STAFF RECOMMENDATION 1808 Sweetbriar Avenue August 21, 2013

Application: New construction - outbuilding
District: Belmont-Hillsboro Neighborhood Conservation Zoning Overlay
Council District: 18
Map and Parcel Number: 10416025900
Applicant: Sandi Adams, Rigid Construction
Project Lead: Sean Alexander, sean.alexander@nashville.gov

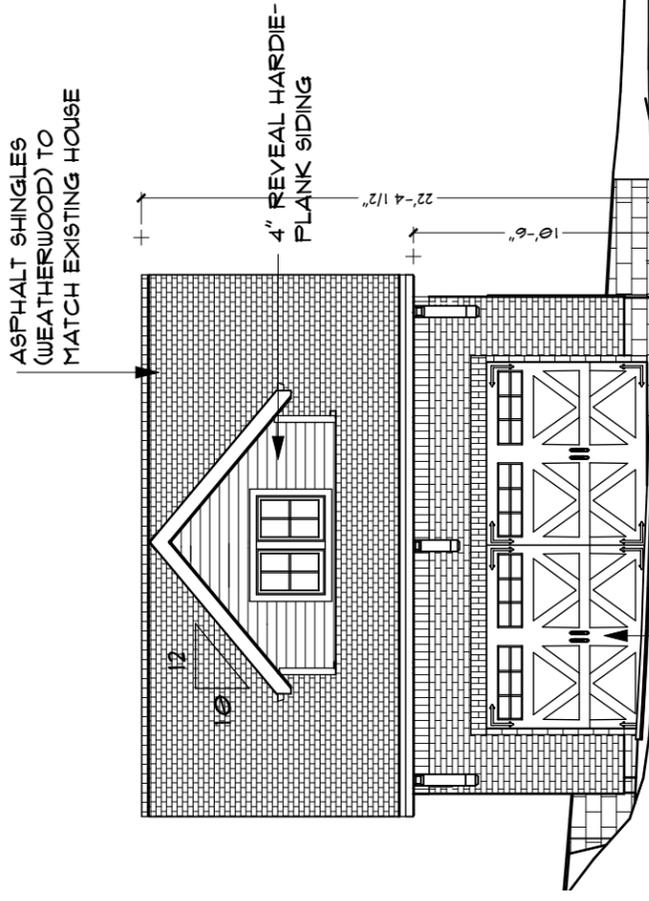
The proportion and location of windows and a pedestrian door on the proposed outbuilding will be compatible with surrounding historic buildings. The vehicle door will be a two-bay, sixteen foot (16') wide door designed to look like two separate doors. Typically, historic outbuildings would have door and window openings proportioned to single bays. Because the garage will be located at the rear of the lot and will be accessed from the side, this opening will be obscured from the public right-of-way by the house and will therefore not be visible. Staff finds the windows and doors to meet guideline II.B.1.g.

2 CAR DETACHED GARAGE

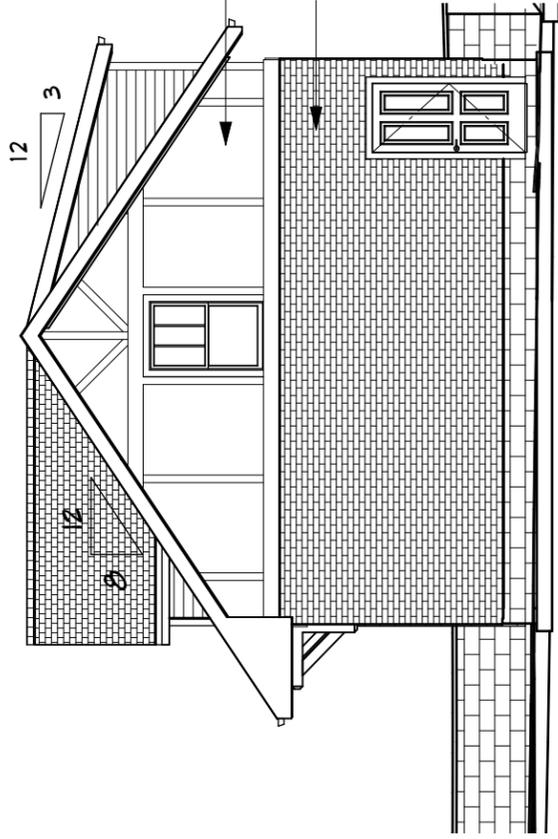
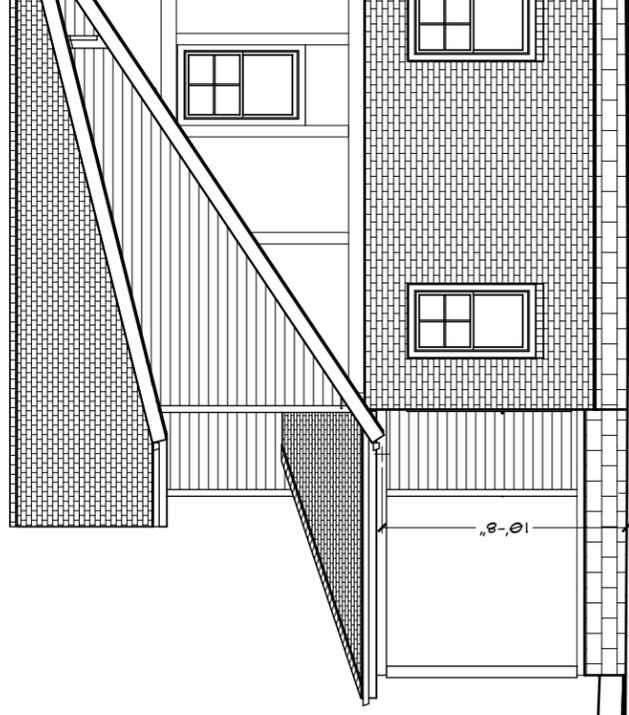
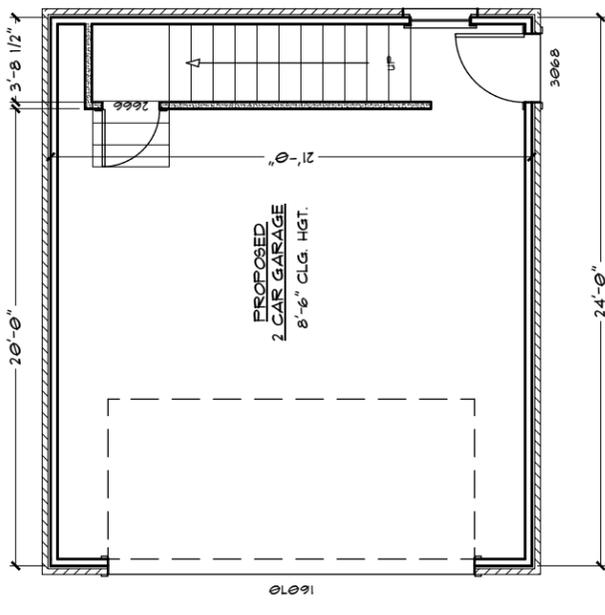
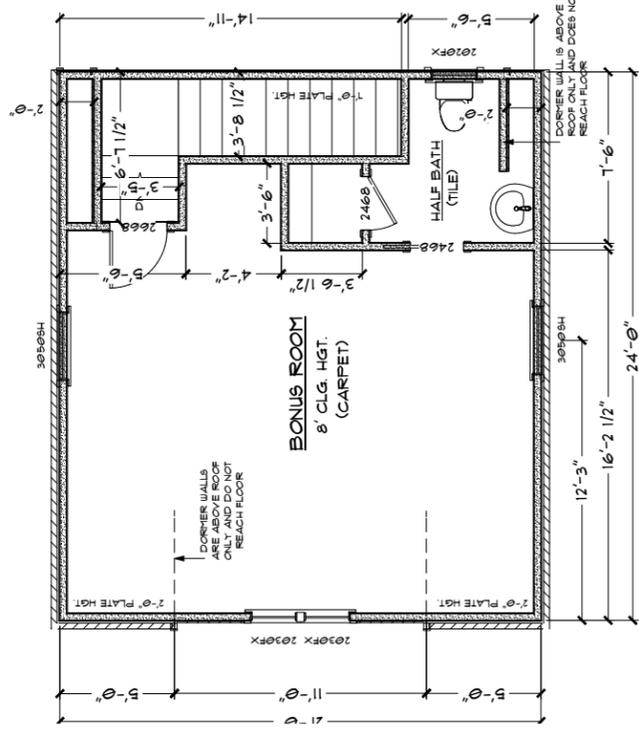
The building will be one and one-half stories tall, with a ridge height of twenty-two feet, four inches (22'-4") and an eave height of ten feet, six inches (10'-6"). The eave height matches the eave line of the house, and the ridge is more than five feet (5') lower than the ridge of the roof of the house. The footprint of the new garage will be nearly square, with a twenty-four foot (24') wide street-side elevation. The total first-floor area of the garage will be five hundred, twenty-eight square feet (528 sq. ft.). The height and scale are compatible with surrounding historic buildings and meet guideline II.B.1.a. and II.B.1.b. In being subordinate to the house to which it is related, the new building will also meet guideline II.B.1.i.1.

The roof of the new outbuilding will be a gable with the ridge running front-to-back, with a gabled dormer on the left side and a shed-roofed dormer on the right. The primary roof pitch will be 8:12, matching the pitch of the roof on the house, with the gable and shed dormers having 10:12 and 3:12 pitches, respectively. These roofs are typical of surrounding historic buildings and are compatible with those of the house to which the structure relates. These roofs meet guideline II.B.1.e.

The materials of the new outbuilding will match those of the house: red brick, cement-fiber "stucco" panels and clapboard siding, cement-fiber trim, a split-faced block

foundation, and a composite shingle roof. The windows will be Fiberglass-clad wood, matching those on the house. These materials are compatible with those of surrounding historic buildings and meet guideline II.B.1.d.

Staff recommends approval of the application to construct a new outbuilding at 1808 Sweetbriar Avenue, finding the proposal to meet the design guidelines for new construction of outbuildings in the Belmont-Hillsboro Neighborhood Conservation Zoning Overlay.
